Transport
for NSW

Heathcote Road Bridge

Addendum Review of
Environmental Factors

April 2022

FIGURE 1-2: The proposed modification

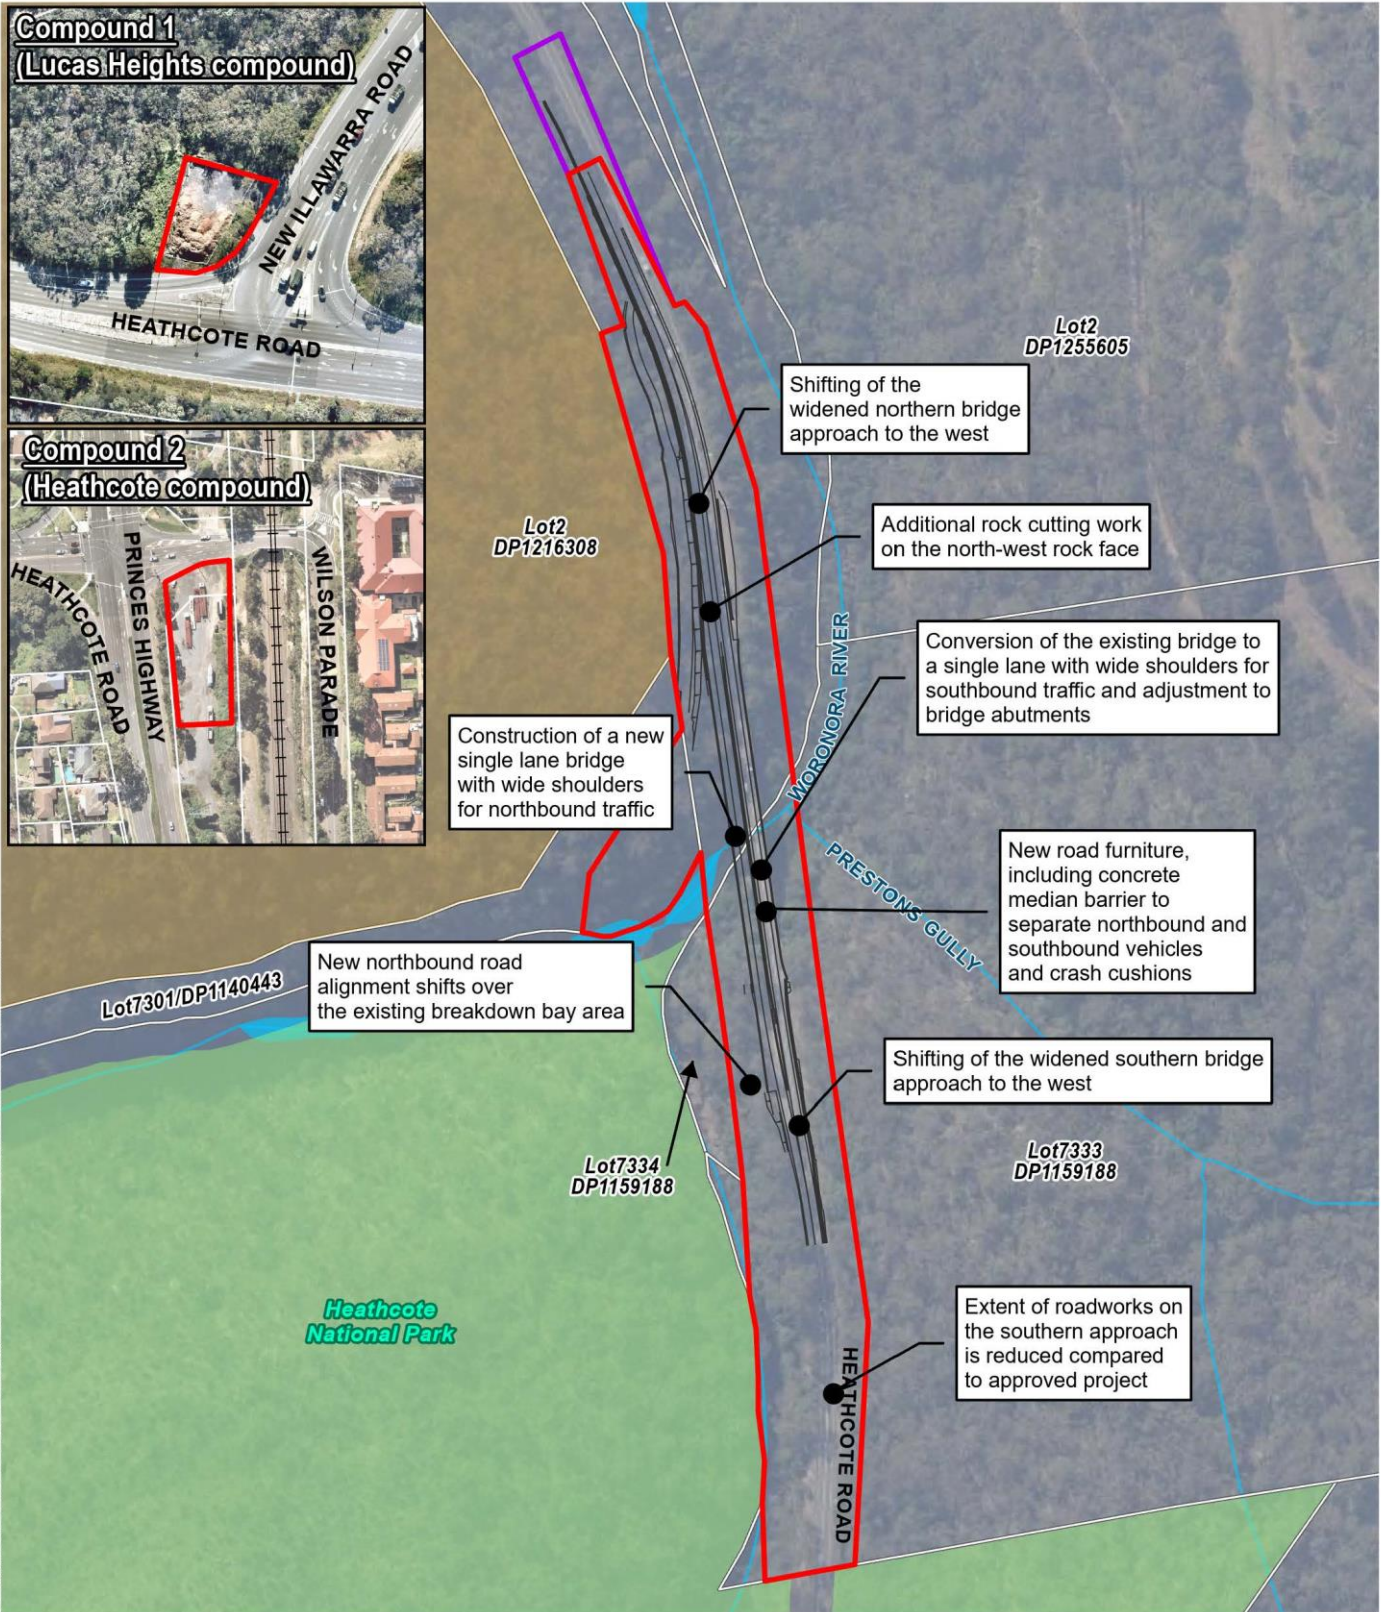
Transport now propose to modify the approved project and pursue the bridge duplication option instead of the bridge widening option. The existing bridge would be converted to a single lane bridge with wide shoulders for southbound traffic. A new single lane bridge would be constructed on the western (upstream) side of the existing Heathcote Road bridge to carry northbound traffic. Upgrades to the northern and southern bridge approaches would still be required and would shift slightly west to align with the new bridge. This improved design provides a physical dividing barrier between opposing traffic lanes. The bridge duplication option is hereafter referred to as the proposed modification.

Construction and operation of the proposed modification would be able to occur mostly within the proposed area identified in the project REF. This is referred to as the approved project boundary in this addendum REF (refer to Section 1.3). Despite this, the area within the approved project boundary required for construction of the proposed modification has changed compared to the approved project. Work would also now be required to extend drainage works within the road corridor slightly to the north of the approved project boundary. As such, a modified project boundary has been adopted for the proposed modification (refer to Figure 1-2 and Section 1.3).

FIGURE 3-1a: Key features of the proposed modification

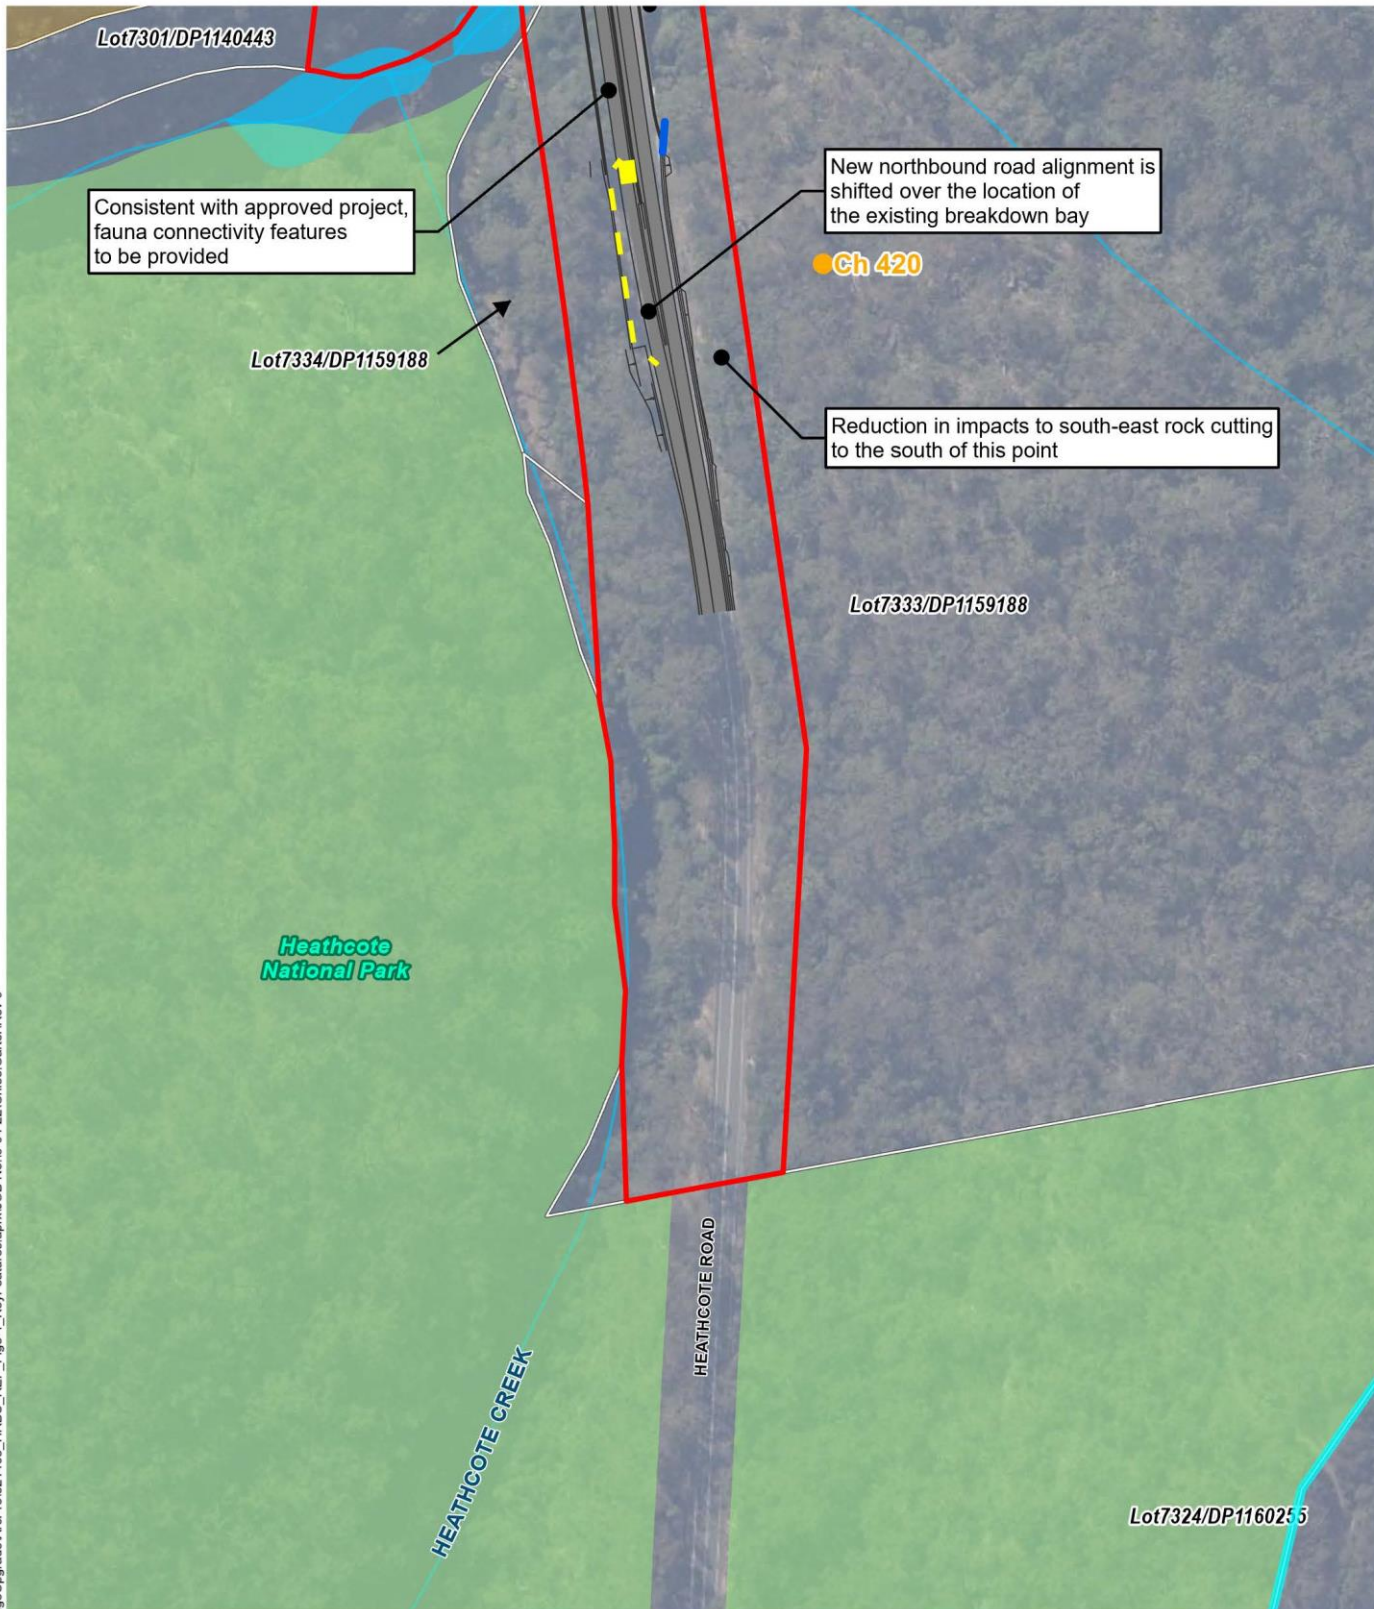
During construction, the southern abutment would be accessed from the proposed new alignment via a maintenance access track running north-south to the west of the alignment which would be maintained during operation (refer to Figure 3-1). The northern abutment would be accessed via the temporary access track (refer to Figure 3-13). There would be no construction vehicle access to the abutments from the valley floor. Access to the valley floor would be by foot only. During operation, there would be staircases directly adjacent to the abutments on the western side of the new bridge which would be provided instead of the metal maintenance stairs included in the approved project. There would be sufficient space for a vehicle to pull over to access the southern abutment for maintenance via stairs adjacent to the wing wall and this access track. There would not be changes to the batter along the access track.

Figure 3-1 indicates the location of the proposed abutments and the maintenance access track compared to the rest of the bridge structure. Figure 3-4 shows a cross-section of the proposed abutment. Figure 3-5 shows a plan view of the new abutments.

Figure 3-2 Typical cross section at Heathcote Road bridge

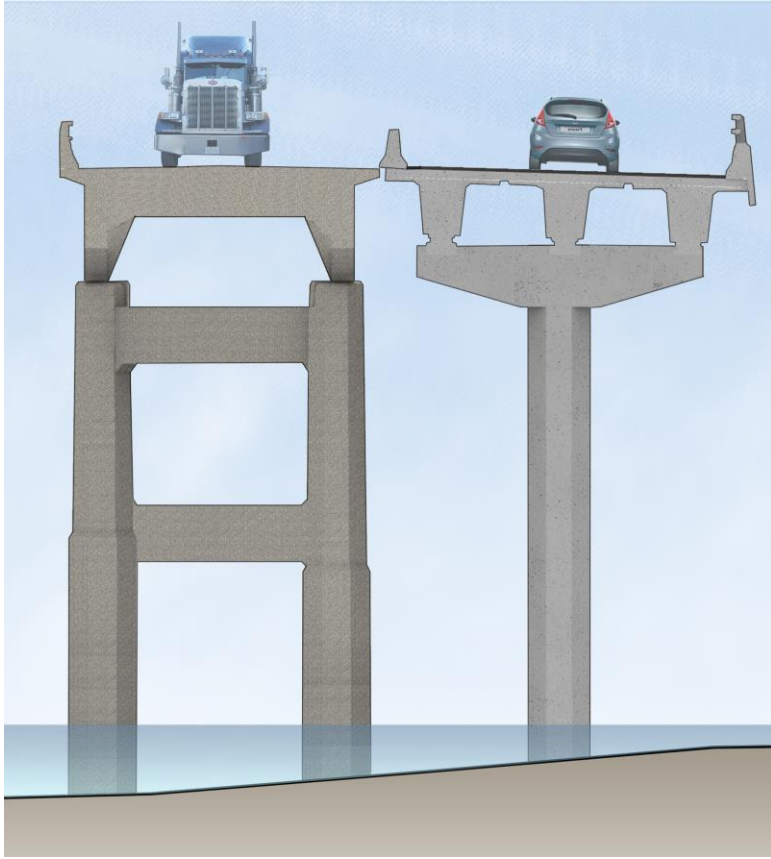
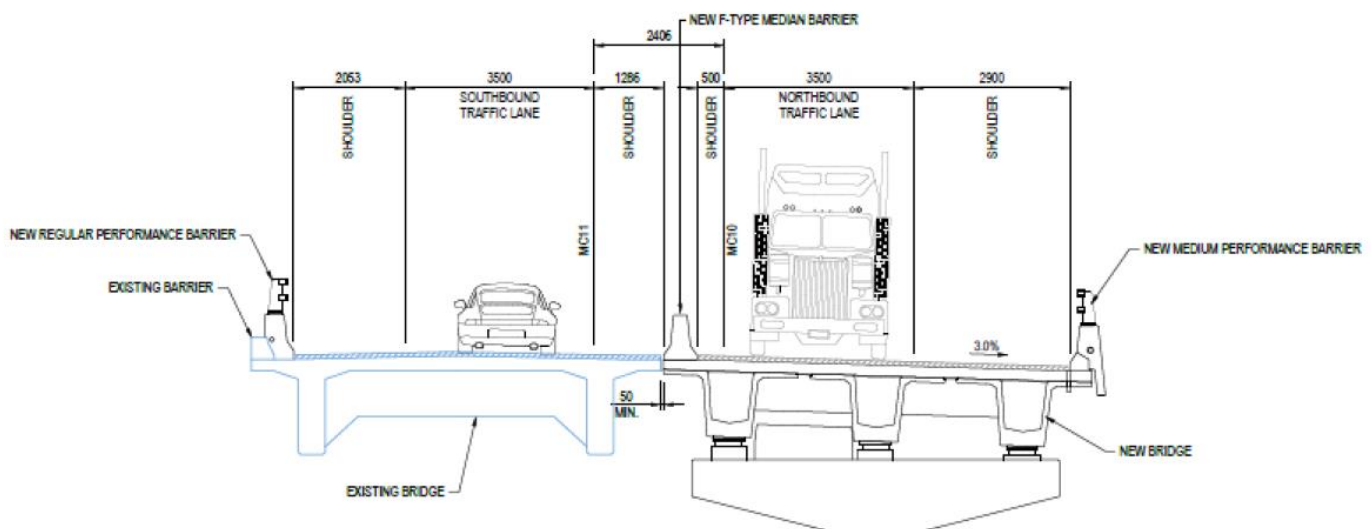
The new bridge would be aligned parallel to the existing bridge, on the western, upstream side (refer to Figure 3-2 and Figure 3-3). The superstructure of the bridge would be about seven metres wide (excluding edge barriers) with super-T girders and a composite cast in-situ deck slab (refer to Figure 3-3). The proposed bridge would be comprised of five spans, about 30 metres long and would have the same height as the existing bridge.

Figure 3-3 Typical cross sections of existing and proposed bridges

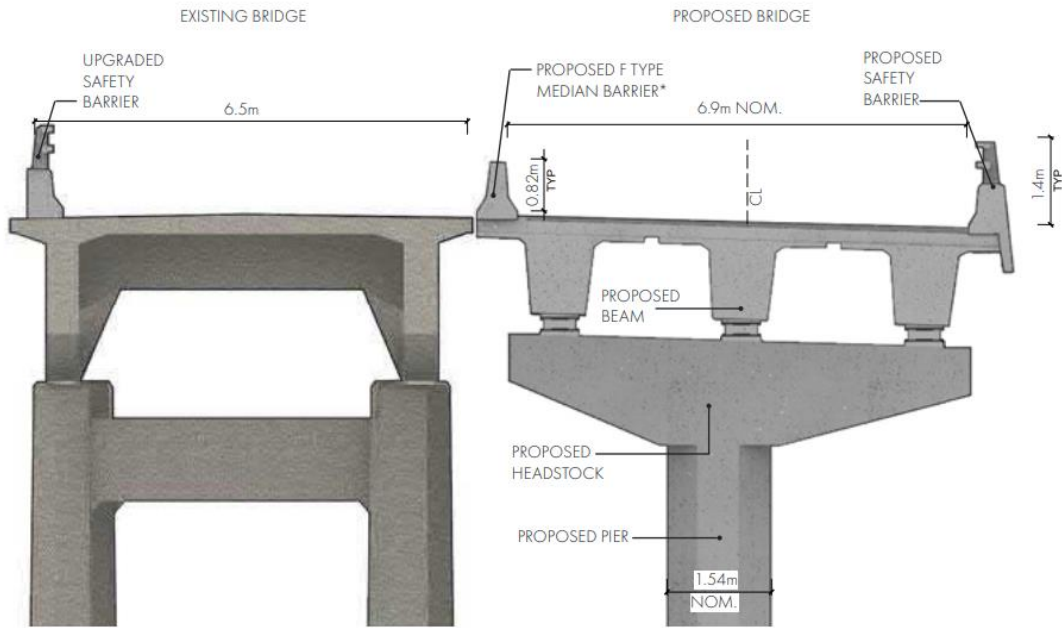
The bridge would include a single 3.5 metre lane with wide shoulders for northbound traffic (refer to Figure 3-3). Type F safety barriers are proposed on both sides of the bridge. The bridge would be constructed primarily out of concrete, with steel elements for the barriers and asphalt for the road surface. It would be a different concrete colour to the existing bridge. The texture of the new bridge would be confirmed during later stages of detailed design.

Figure 3-4 Proposed abutment treatment

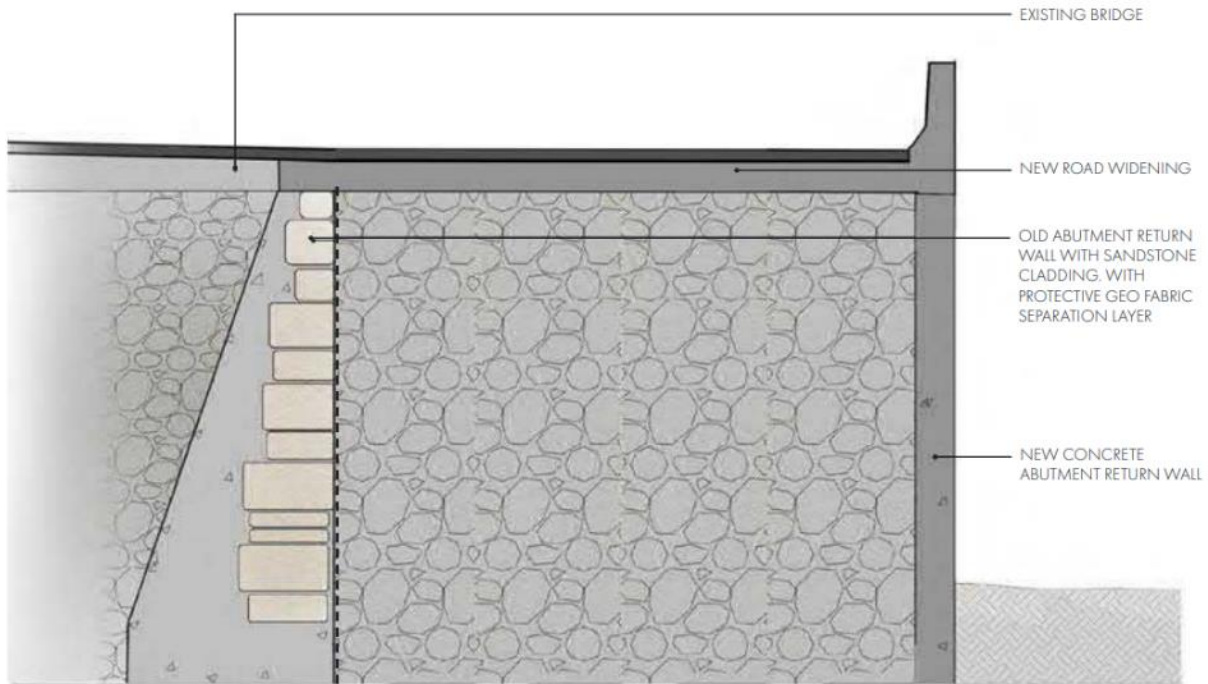
It was originally proposed to remove existing sandstone at the abutments and re-use it elsewhere in the design, however further investigation has determined the stone to be a capping layer only. As part of the proposed modification, the existing sandstone facing would be capped for protection and expanded with a new widened abutment to accommodate both bridges (refer to Figure 3-4).

Figure 3-6 General arrangement – piers

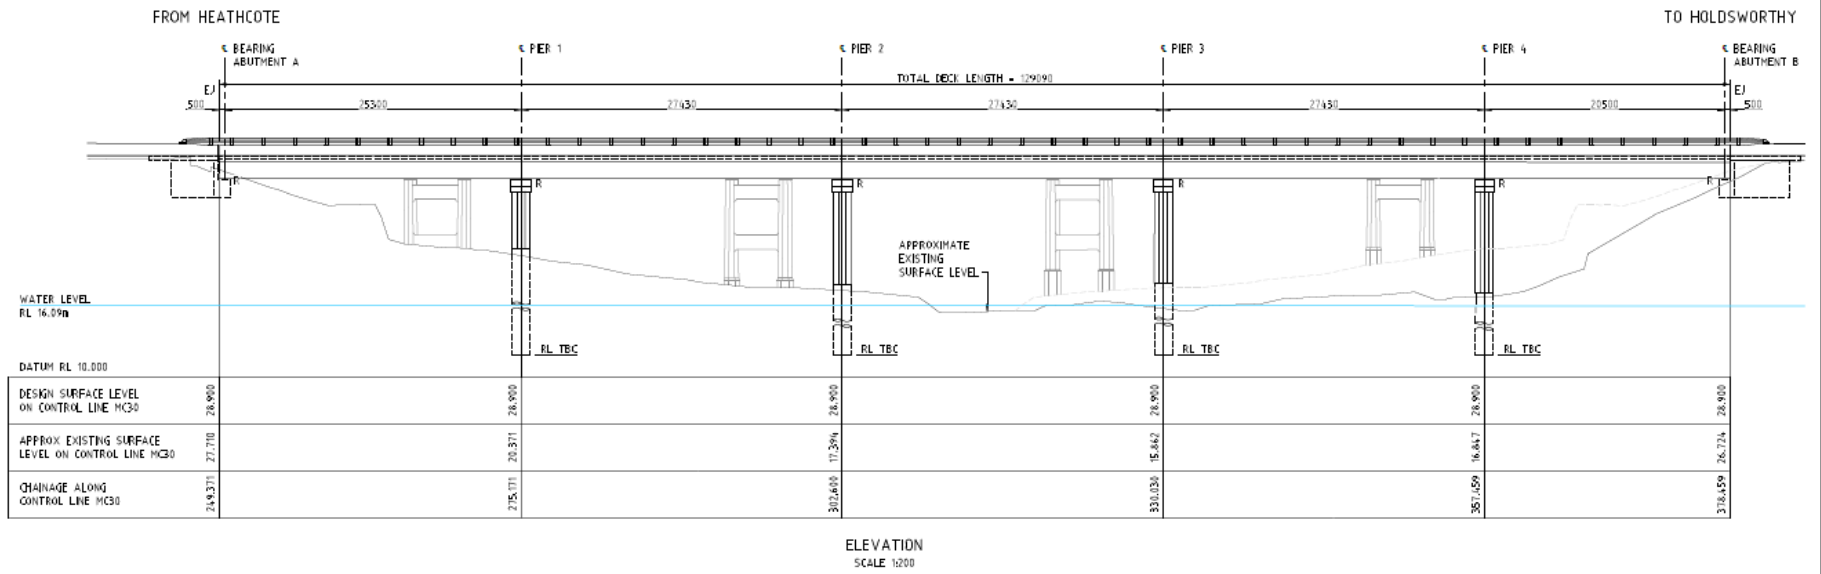
The substructure would consist of four new piers. The bridge piers would be hexagonal matching the existing piers on the current Heathcote Road Bridge. These would align with the existing piers as shown in Figure 3-6. They are designed to match the skew and width of the existing piers. The piers have been designed to be octagonal to complement the existing bridge piers and also minimise hydraulic impacts.

Figure 3-7 Cross section of northern approach – Ch 120

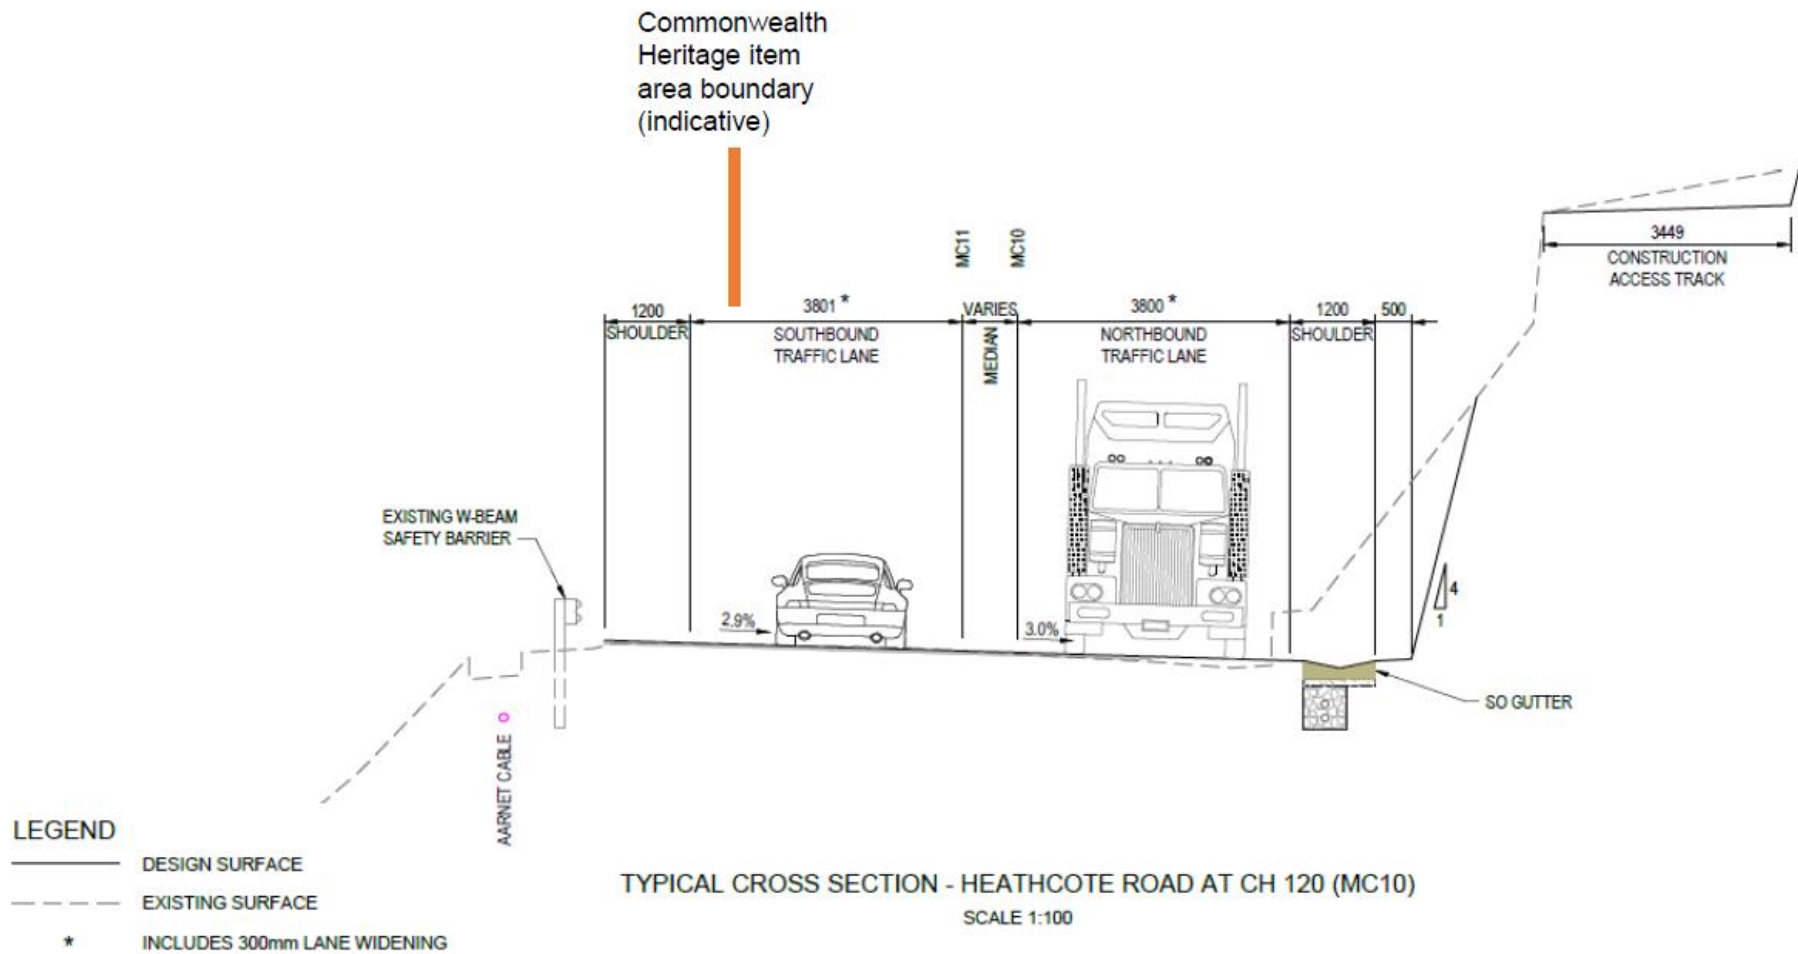
Figure 3-7 and Figure 3-8 shows cross sections of the proposed upgrades to the northern approach. Figure 3-1 indicates the chainage locations for these figures.

The proposed modification would require additional excavation on the rock cutting located on the north-west side of the existing bridge (refer to Figure 3-1). This cutting would be accessed from the top to allow materials to be safely and efficiently removed. The extent of the cutting varies but is generally about nine metres at the southern end, five to seven metres in the mid-point of the cut and tapering from three to zero metres at the tie-in on the northern extent. The north-west rock cutting is about 150 metres long in total. This cut is also shown in Figure 3-7 and Figure 3-8.
